BLUE SPRINGS MEADOW
EL PASO COUNTY
CONSTRUCTION DRAWINGS
AUGUST 2026

EPC STORMWATER REVIEW COMMENTS
IN ORANGE BOXES WITH BLACK TEXT

BLUE SPRINGS MEADOW
CONSTRUCTION DRAWINGS
COVER SHEET

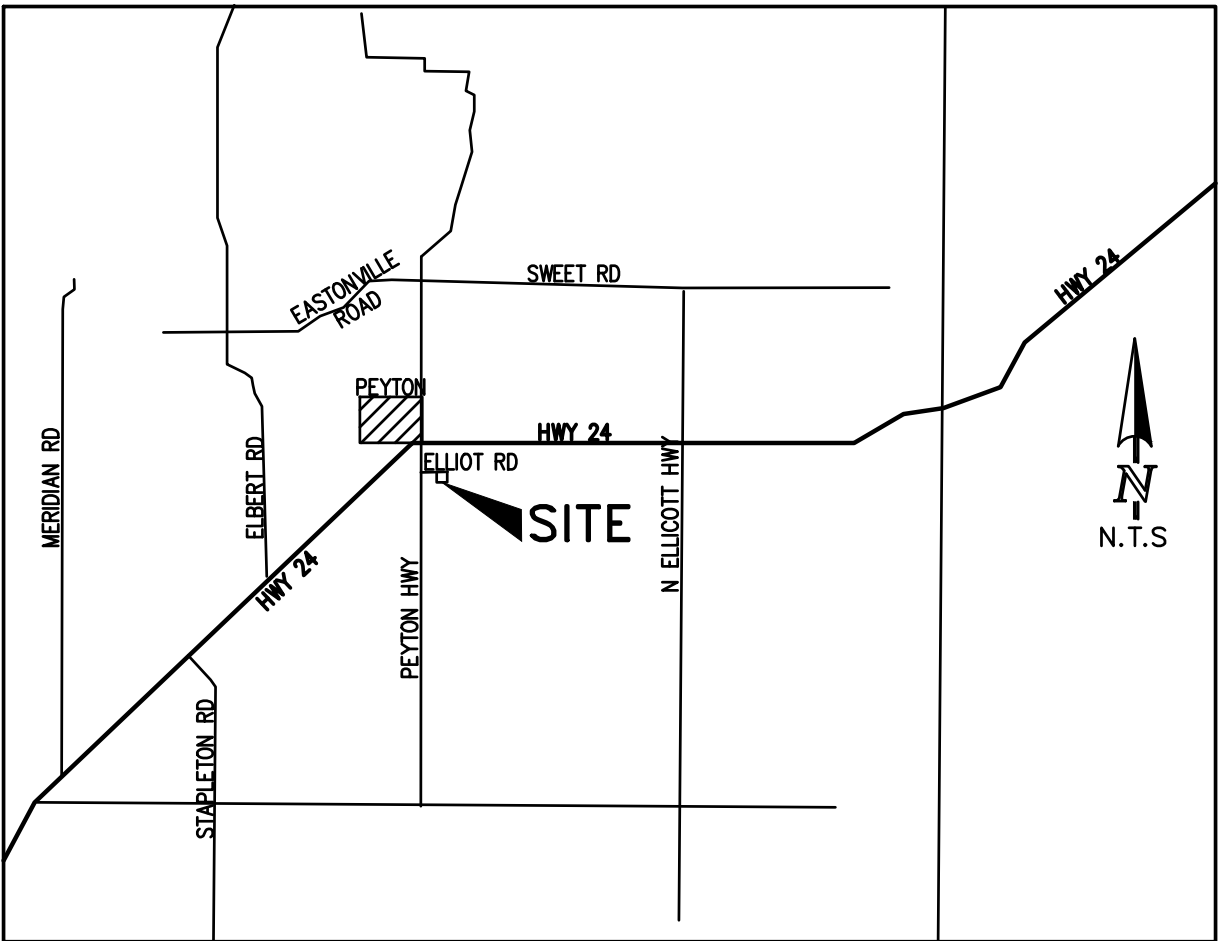
Please execute this sheet.

CONSTRUCTION DRAWINGS
GRADING & EROSION CONTROL
INITIAL PHASE

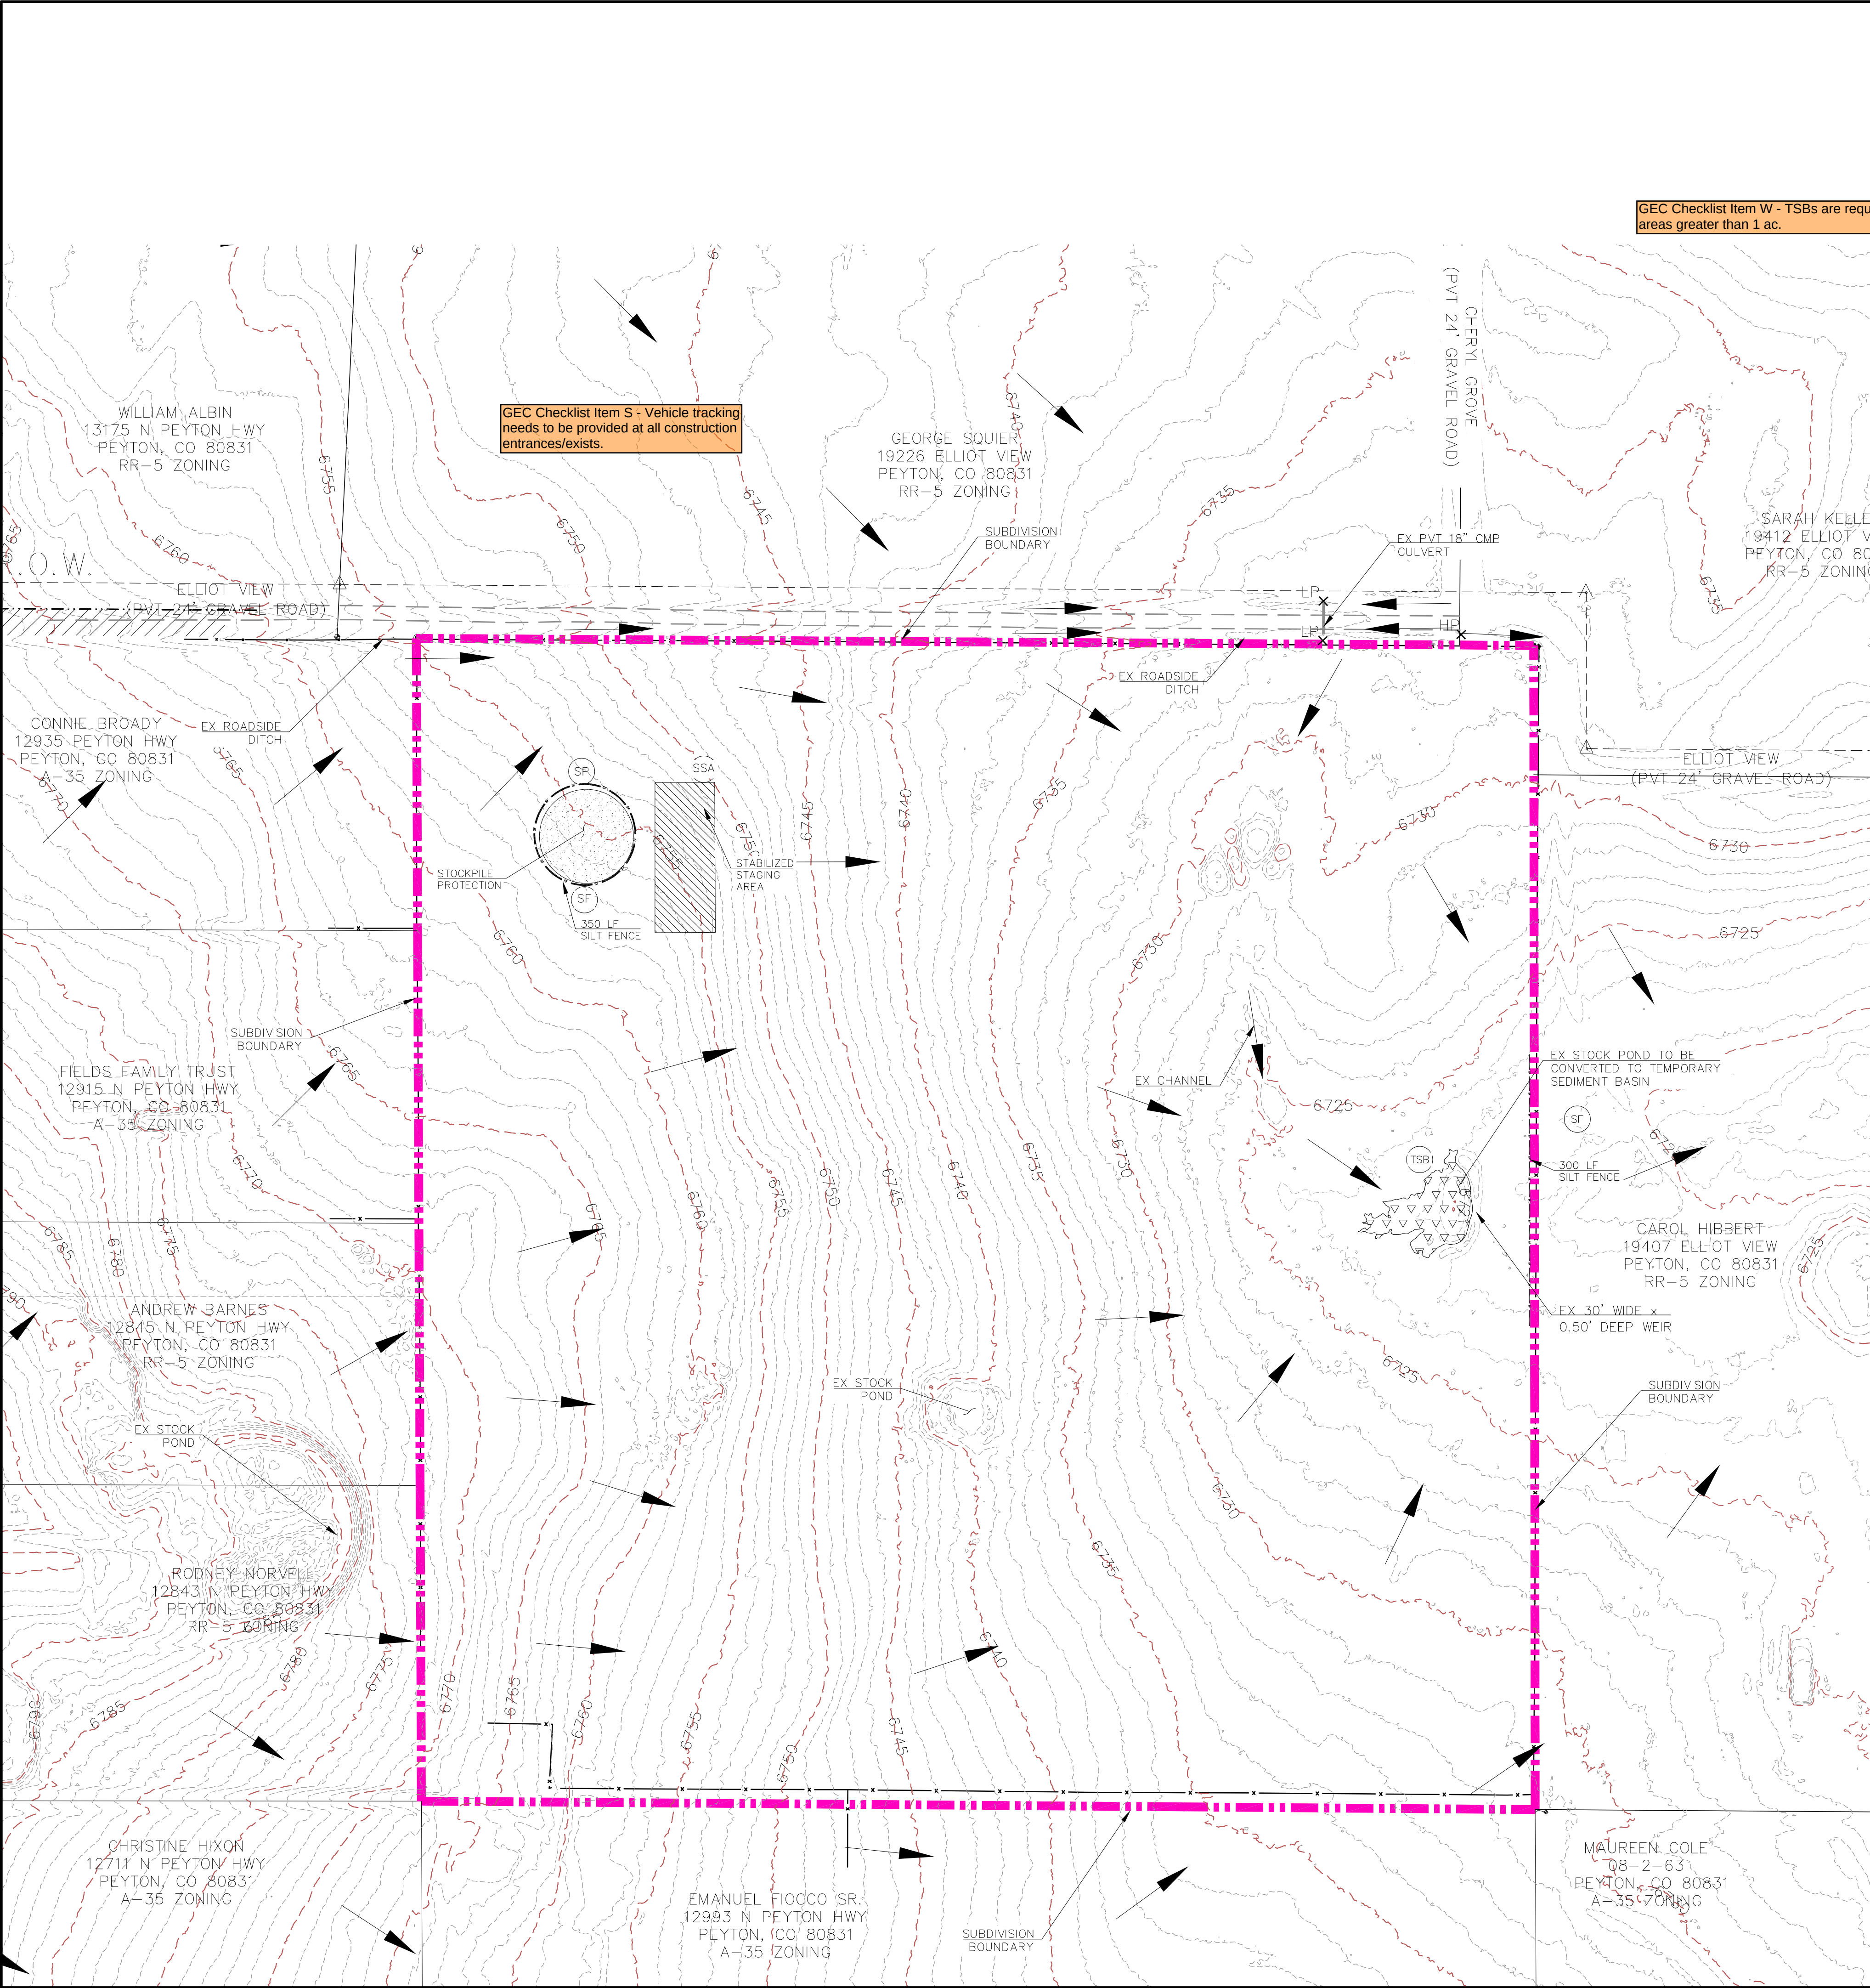
Is this accurate? You already have a GEC Plan.

GEC Checklist Item L - If "limits of disturbance" and "construction boundary" are the same, change to "limits of construction/disturbance" or otherwise show as separate line types for each on the legend and figure.
Note: limits of disturbance and construction still need to be shown on the initial phase.

CONSTRUCTION DRAWINGS
GRADING & EROSION CONTROL
INTERIM PHASE

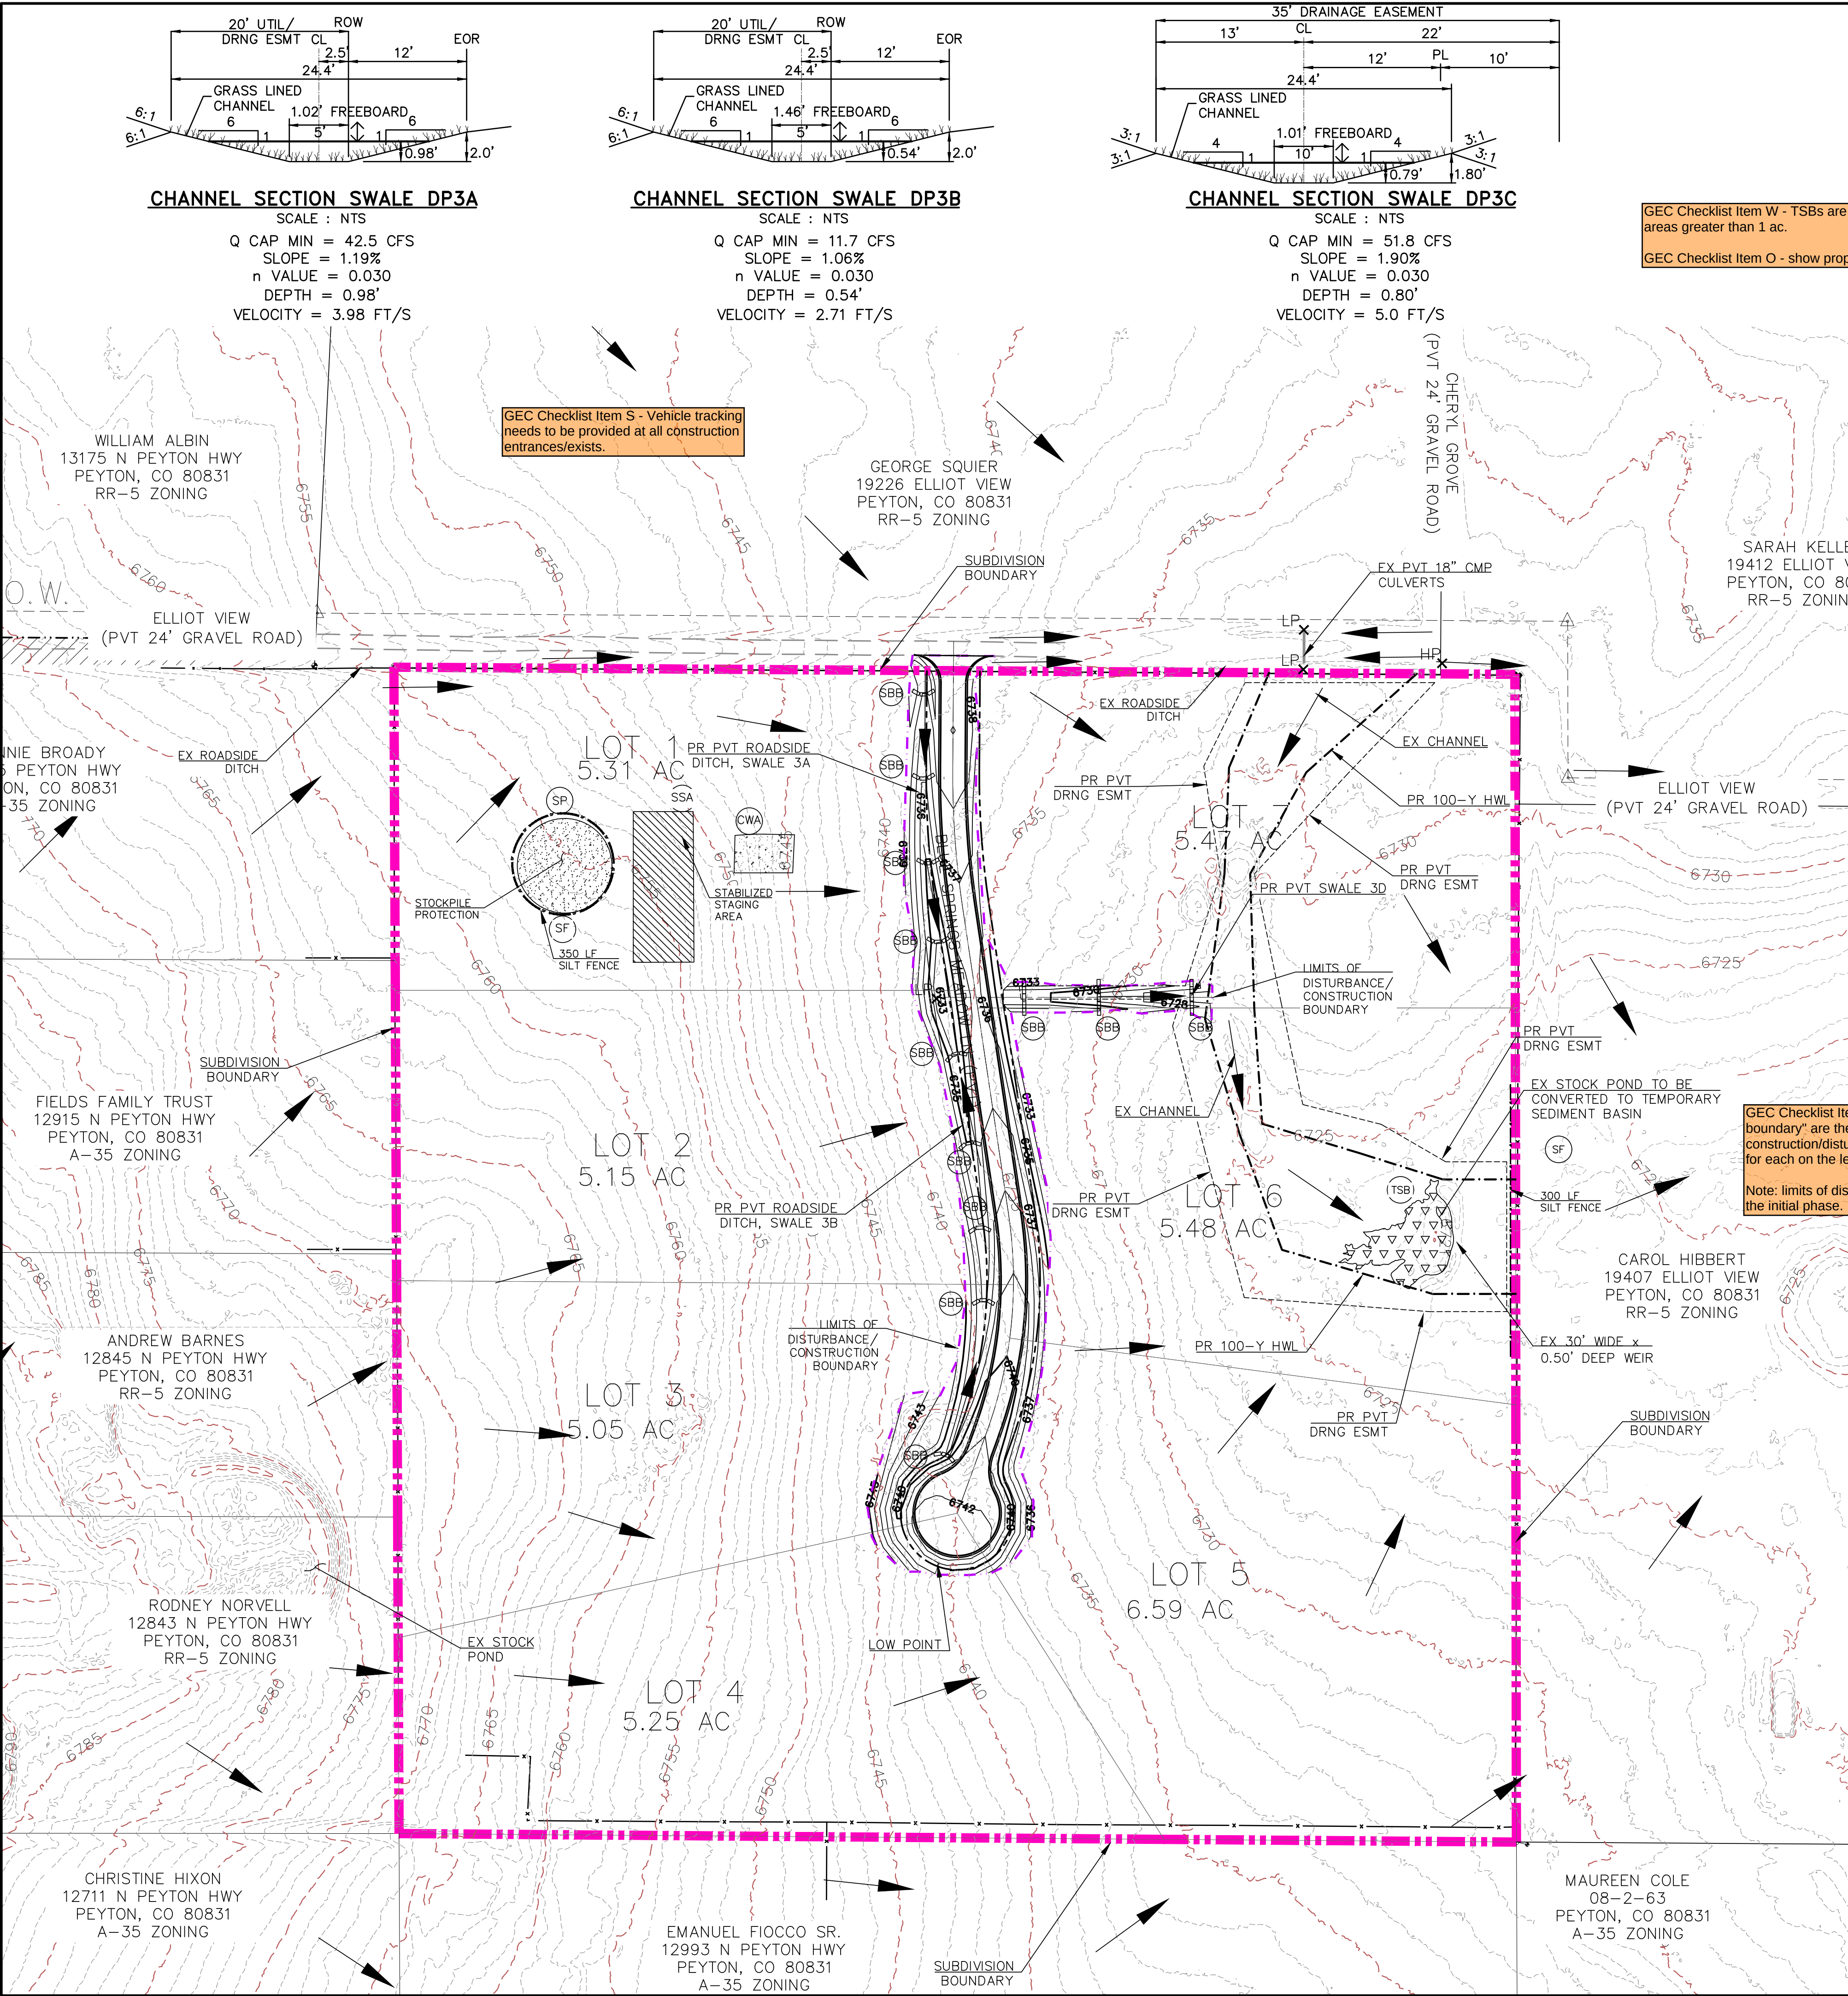
Is this accurate? You already have GEC Plan
